H & T SUBDIVISION

Engineering Comments: FINAL PLAT COMMENTS (should be addressed prior to submitting the FINAL PLAT for review and/or signature by the City Engineer):

APPLICATION NUMBER 5 DATE November 7, 2019

DETAIL SITE PLAN

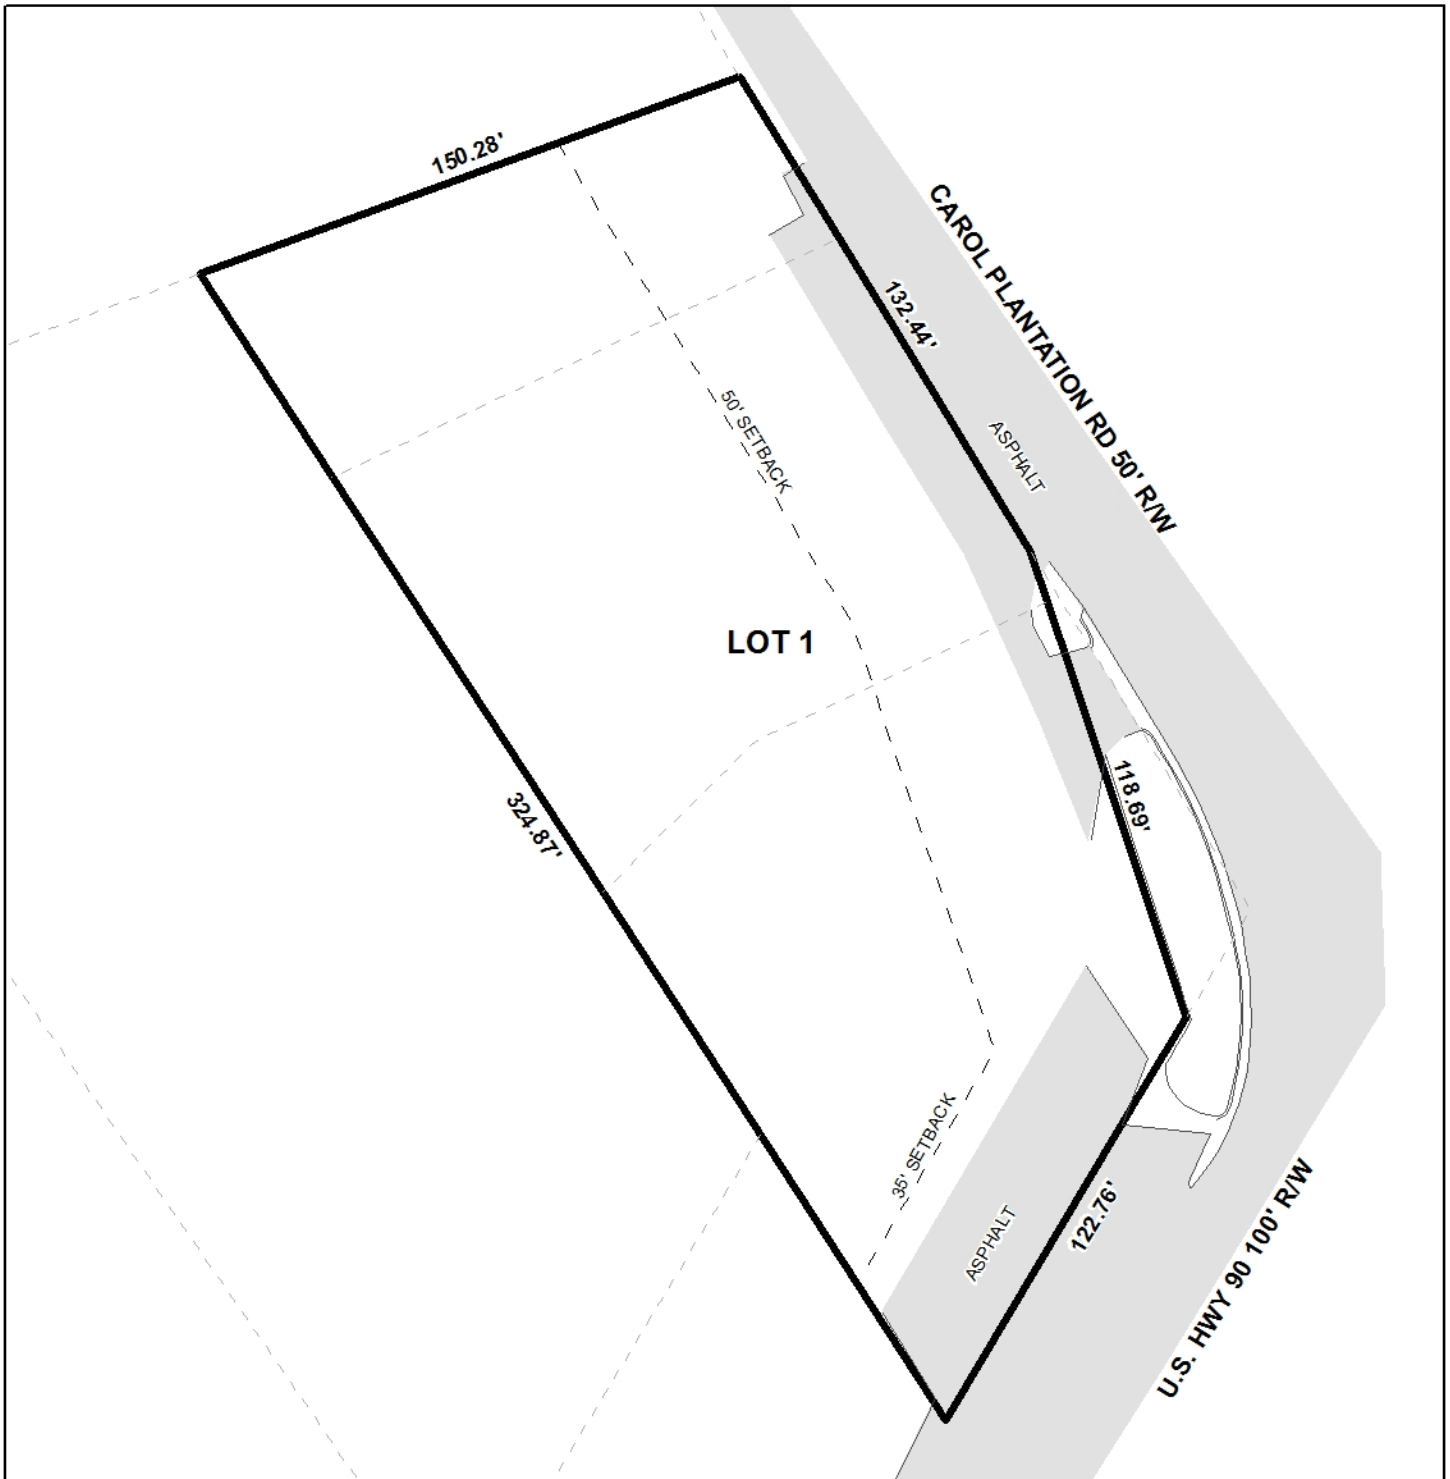
The site has frontage on U.S. Highway 90 West and Carol Plantation Road, which are both major streets on the Major Street Plan. U.S. Highway 90 West, should have a right-of-way width of 120 feet, and is shown to have an existing right-of-way width of 100 feet. Carol Plantation Road

should have a right-of-way width of 100 feet, and is shown to have an existing right-of-way width of 50 feet. In lieu of dedication, the applicant is proposing increased setbacks along both street frontages, thus resulting in a 35 foot building setback along U.S. Highway 90 West and a 50 foot building setback along Carol Plantation Road. Dedication was required for the property next door by the Planning Commission during a 2010 Subdivision request, thus it would not be unreasonable to require dedication for this site. It should be noted that since the adjacent site provided dedication, the Major Street Plan was updated, and the planned right-of-way for U.S. Highway 90 West has been reduced from 250 feet. However, if the Planning Commission decides to not require dedication, then a waiver of Section V.B.14. of the Subdivision Regulations would be required.

As on the preliminary plat, the lot size label should be retained in both square feet and acres on the Final Plat adjusted for any required dedication, or a table should be furnished on the Final Plat providing the same information. No easements are indicated on the preliminary plat. If any easements are recorded on the site they should be indicated and labeled on the Final Plat, and a note should be placed on the Final Plat stating that no structure may be placed or constructed within any easement.

- 1) dedication to provide 60 feet from the centerline of U.S. Highway 90 West;
- 2) dedication to provide 50 feet from the centerline of Carol Plantation Road;

- 3) depiction of the 25 foot building setback along both street frontages, adjusted for dedication;
- 4) retention of the lot size in both square feet and acres, or the furnishing of a table on the Final Plat providing the same information, adjusted for dedication;

- 5) if an easement is depicted, placement of a note on the Final Plat stating that no structure may be constructed or placed within any easement;
- 6) compliance with the Engineering comments: *(FINAL PLAT COMMENTS (should be addressed prior to submitting the FINAL PLAT for review and/or signature by the City Engineer): A. Provide all of the required information on the SUBDIVISION PLAT (i.e. signature blocks, signatures, certification statements, written legal description, required notes, legend, scale, bearings and distances) that is required by the current Alabama State Board of Licensure for Professional Engineers and Land Surveyors. B. Provide the Surveyor's, Owner's (notarized), Planning Commission, and Traffic Engineering signatures. C. Add a note to the SUBDIVISION PLAT stating that as shown on the 1984 aerial photo (FLIGHT 20 - #94) LOT 1 will receive some historical credit of impervious area towards stormwater detention requirement per Mobile City Code, Chapter 17,*
